Wireless broadband and radio altimeter coexistence Outcomes paper

JUNE 2023

Figure 1: Boeing protection geometry

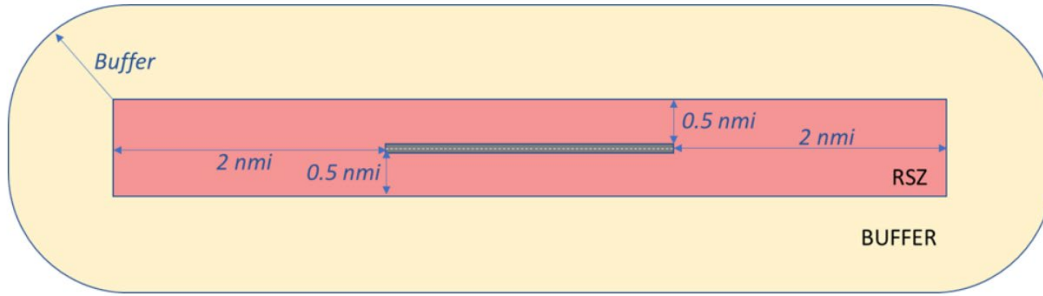
- 3.9 Figure 1 represents the proposed geometry around runways in the Boeing submission, with the Runway Safety Zone (RSZ) and a base station EIRP-dependent buffer zone. Transmissions are prohibited across the whole of these 2 areas.

Figure 3: Comparison of Group 2 and Usage Category 1 protection below 1,000 ft

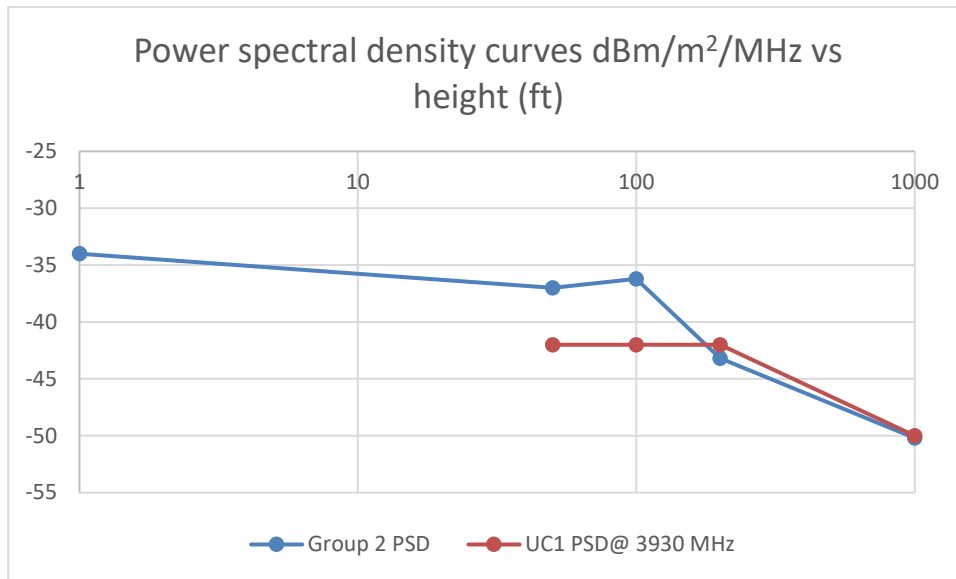
- 4.6 Figure 3 below compares the Group 2 and Usage Category 1 protection. Usage Category 1 offers the same or better protection than Group 2, especially as an additional 6 dB factor is also used in our method when determining the size of exclusion zones.

- 4.7 Consequently, the differences compared with the ACMA proposal derivations are:
- i) desired protection of a larger RSZ areas compared with the runway/s alone
